ADDENDUM 2

Jefferson Twp. LSD-HS Ag Ed Facility

Jefferson Township Local School District
2625 South Union Road
Dayton, OH 45417

Comm. No. 2024006.01

1 FIRST FLOOR PLAN - AG ED SHOP
A101 1/4" = 1'-0"

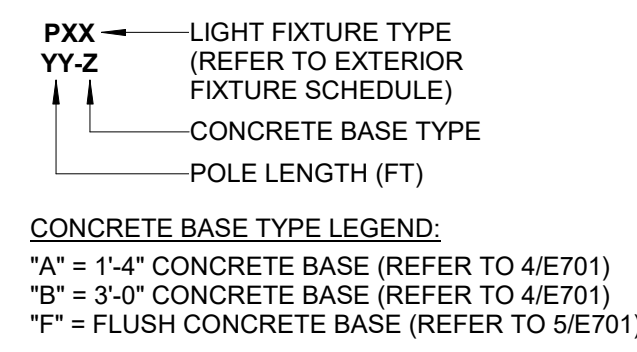
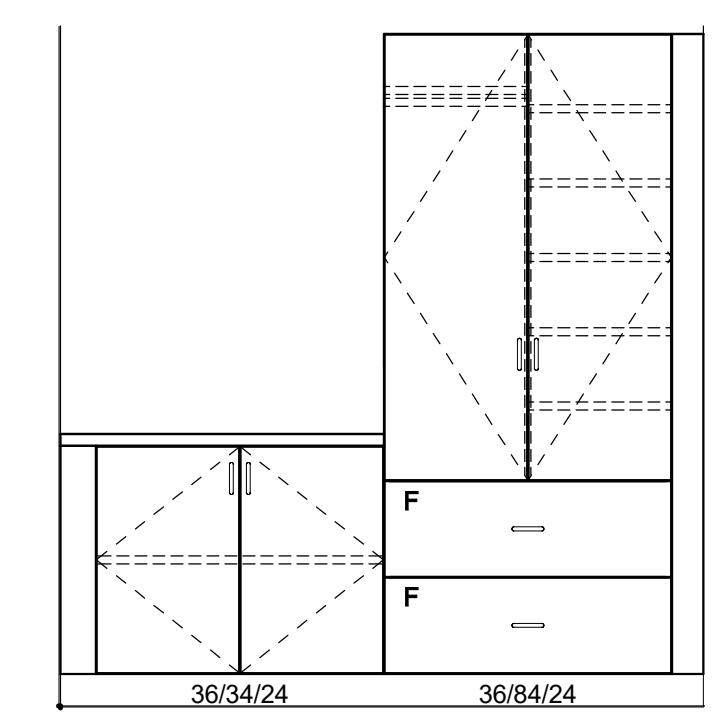
ITEM 1 – Drawing Sheet A101- FIRST FLOOR PLAN - AG ED SHOP:

- A. Revision. Delete Sheet A101 - FIRST FLOOR PLAN - AG ED SHOP and replace with attached Sheet A101 - FIRST FLOOR PLAN - AG ED SHOP.
1. SE15, SE17 and SE18 shall be included in the project.
 2. Provided typical dimension for the welding booths.

1 POWER PLAN - AG LAB
 E200 1/4" = 1'-0"

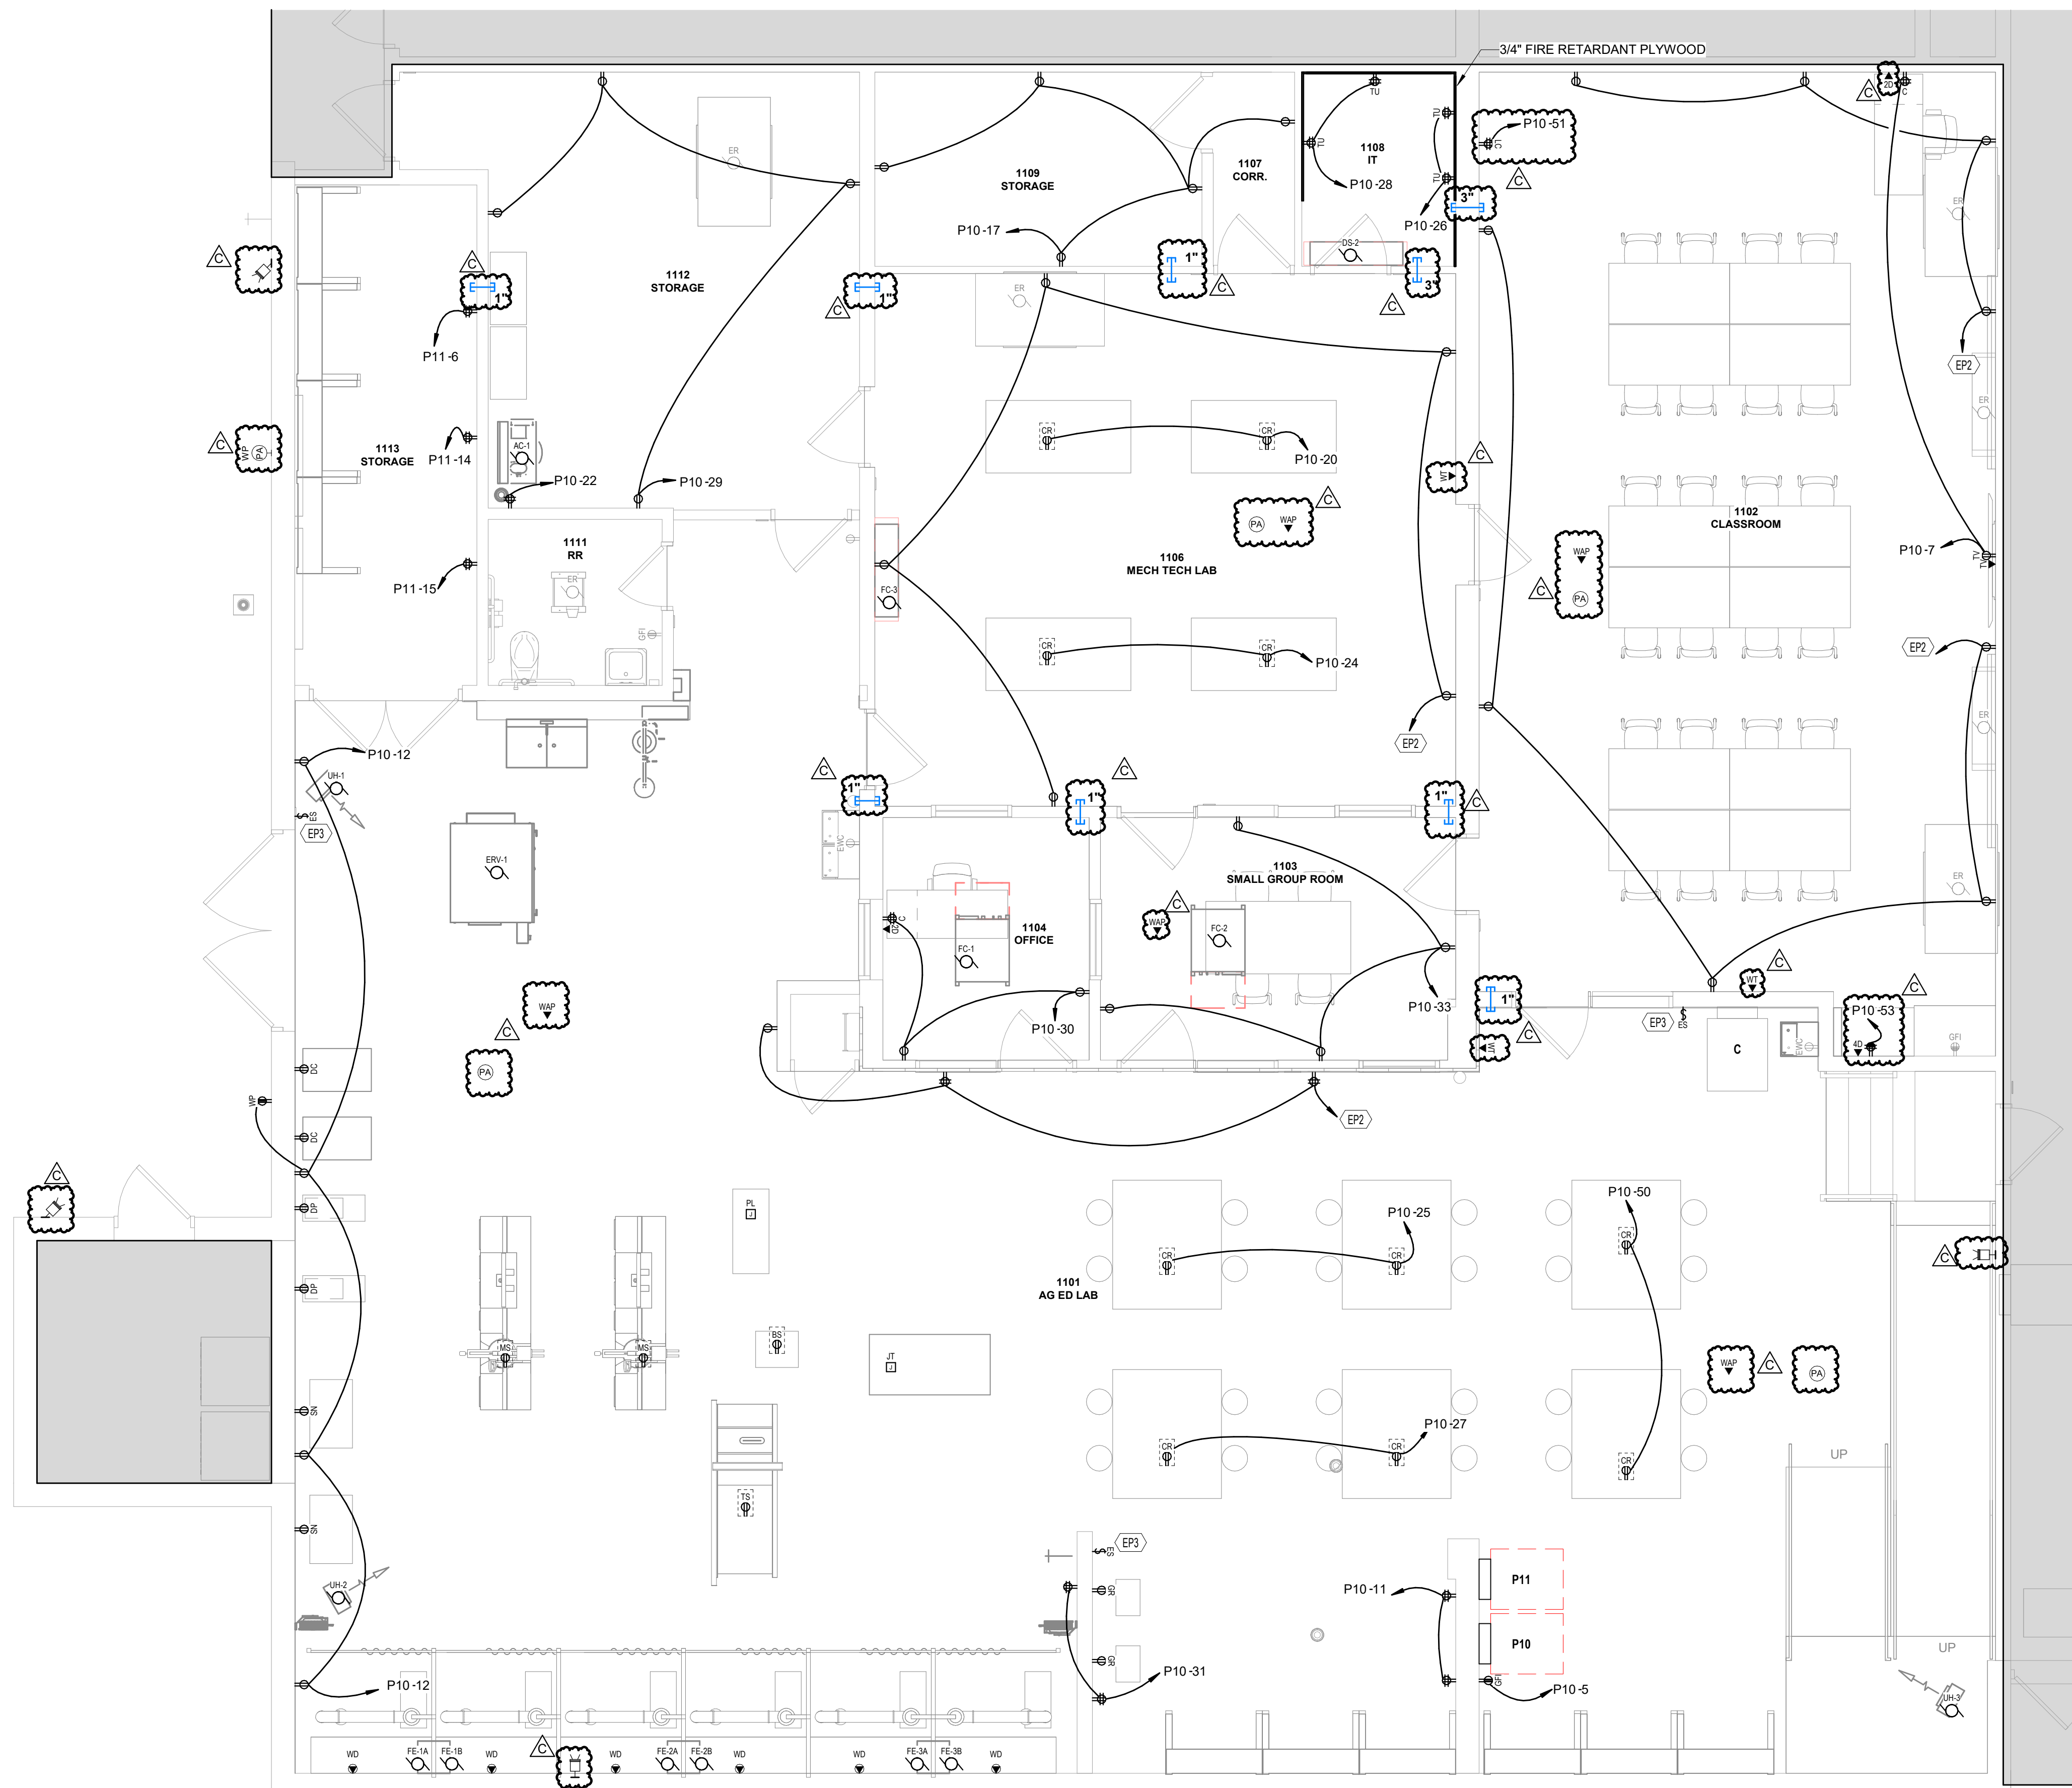
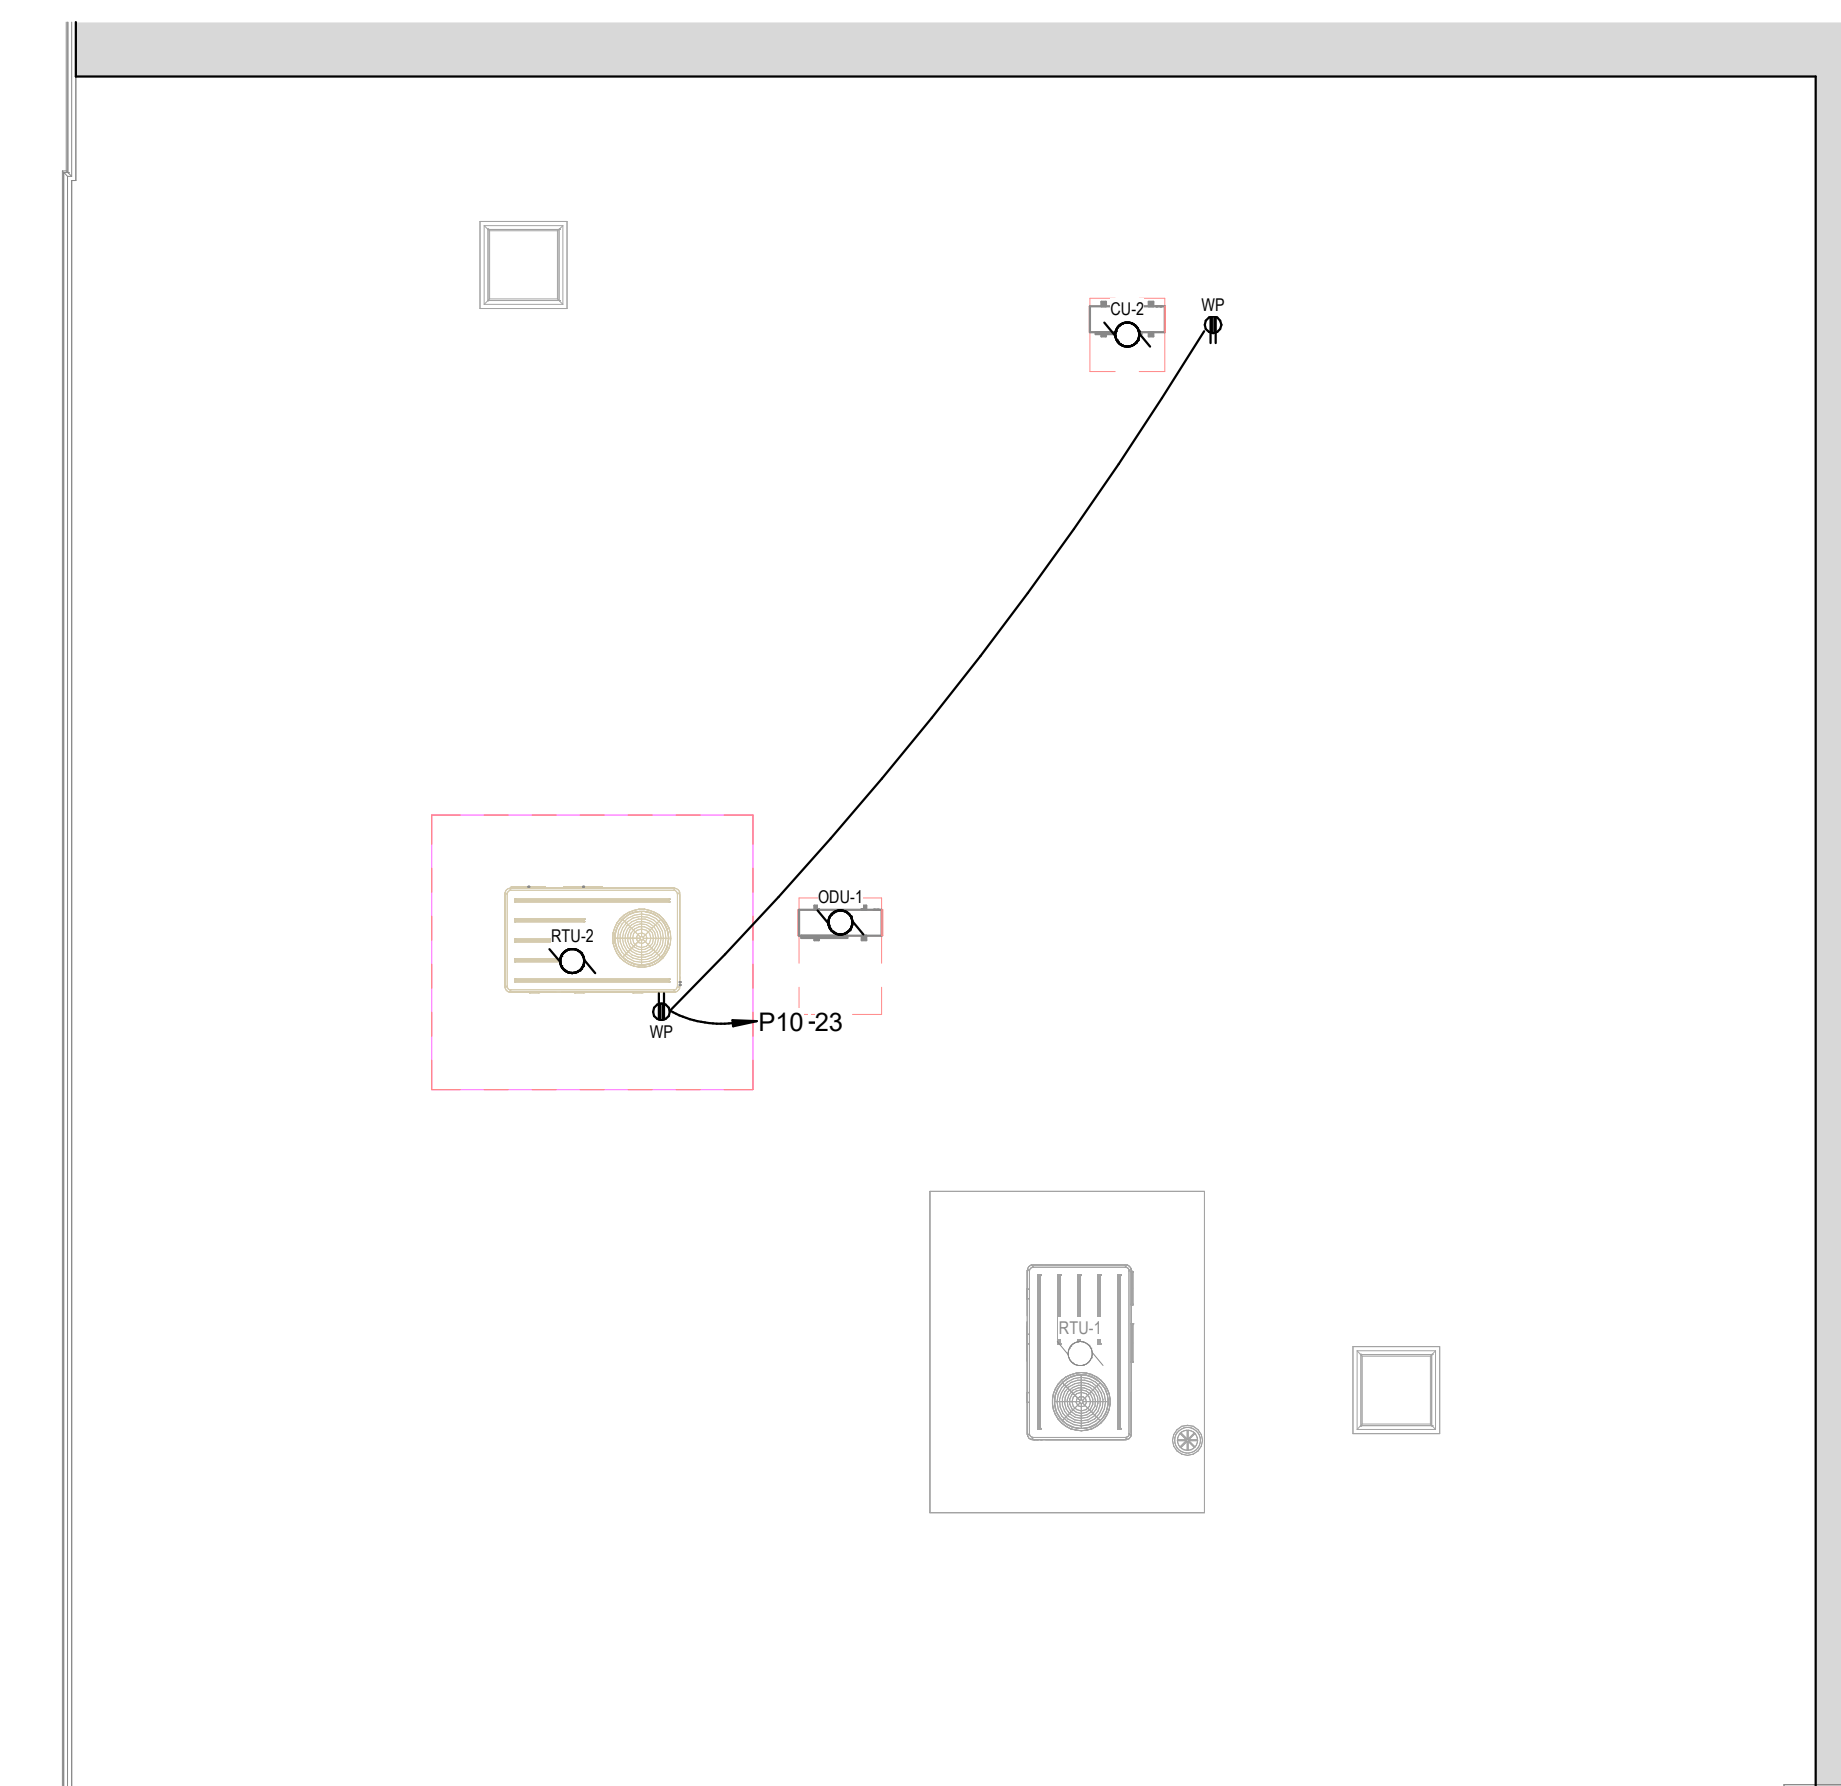
ITEM 4 – Drawing Sheet E200 - POWER PLAN - AG LAB:

- A. Revision. Delete Sheet E200 - POWER PLAN - AG LAB and replace with attached Sheet E200 - POWER PLAN - AG LAB.
1. Added General Technology Notes.
 2. Added security cameras, wall telephones, wireless access points, PA speakers, and sleeves throughout Ag Lab
 3. Added receptacles and data for the above counter printers in 1102.
 4. Revised data quantity for teacher's desk in 1102.
 5. Added receptacle for laptop cart in 1102
